Section 75W Modification Application – Addition of Helipad

*Trinity Point Marina & Mixed Use Development Concept Approval (MP 06_0309)
Lot 31 DP 1117408, Pt Lot 32 DP 1117408, Pt Lot 33 DP 1117408, and Pt Crown Land (the Lake)*

Plan Showing Location of Proposed Helipad

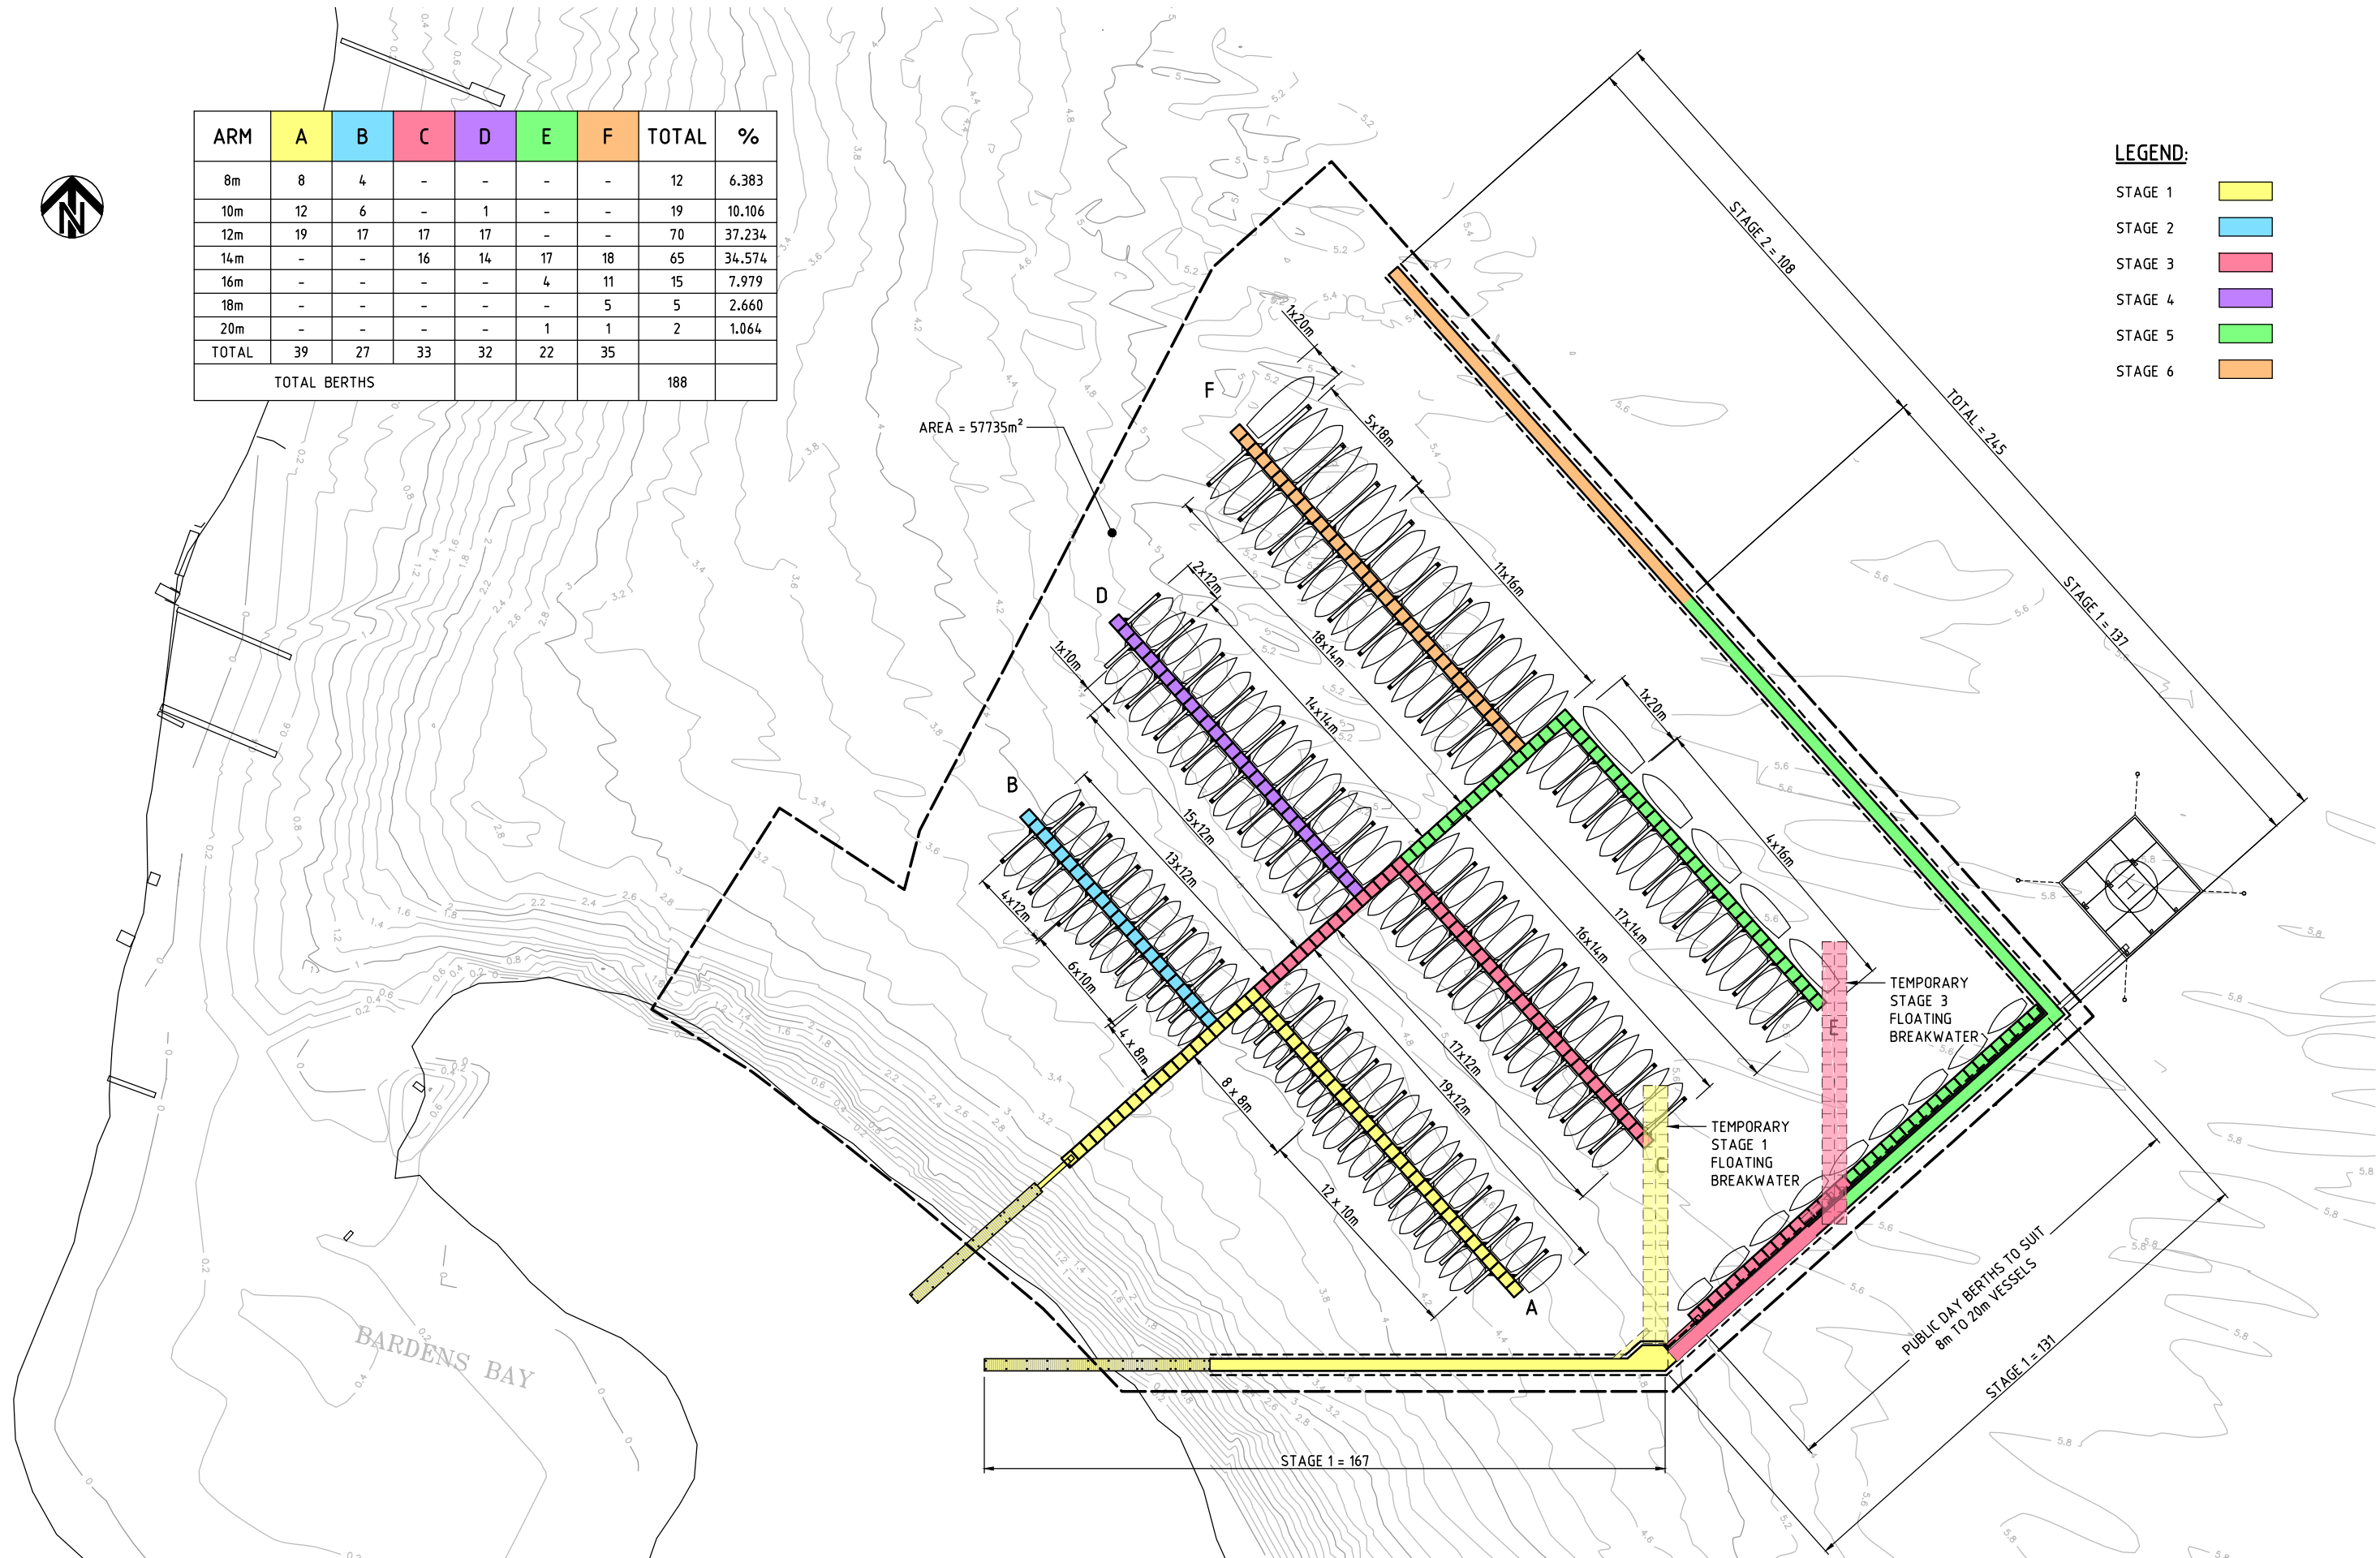
The details and location of the helipad primarily remain the same as was originally proposed in the concept plan application (prior to its removal before determination of the concept plan application). The details of the helipad include:

- 25m x 25m steel helicopter landing pontoon located to the east of the marina.
 - An access gangway to the helipad will extend directly from the breakwater walkway.
 - No night time movements (except emergency services).
 - No re-fuelling.
 - A maximum of 6 movements per week.
- It is noted that this represents a reduction to the helicopter movements that were proposed as part of the original application which included a maximum of 28 movements per week (14 flights).
- Provided in Attachment A is a plan showing the location of the proposed helipad.

Four locations were considered as part of the design process, and ultimately the location shown to contain the helipad (see Attachment A) was determined to be the most suitable location having regard to helicopter types, the presence of marine craft and people within the vicinity, final approach and take off area, ground effect area, landing and lift off area, flight paths and relevant design criteria.

- Part A Table to be updated to include 'helipad'.
- Conditions A1, A2, A3 to be updated to reference the s75W modification letter dated 1 October 2013 prepared by Johnson Property Group (and any subsequent documentation).
- Conditions A2 and A3 to be updated to reference plans 'Trinity Point Marina Ultimate Layout With Helipad' (130827-Ultimate Layout with Heli-SC-001) prepared by SMEC Australia.
- Additional conditions inserted describing the acoustic assessment methodology. Refer Acoustic Assessment Methodology.
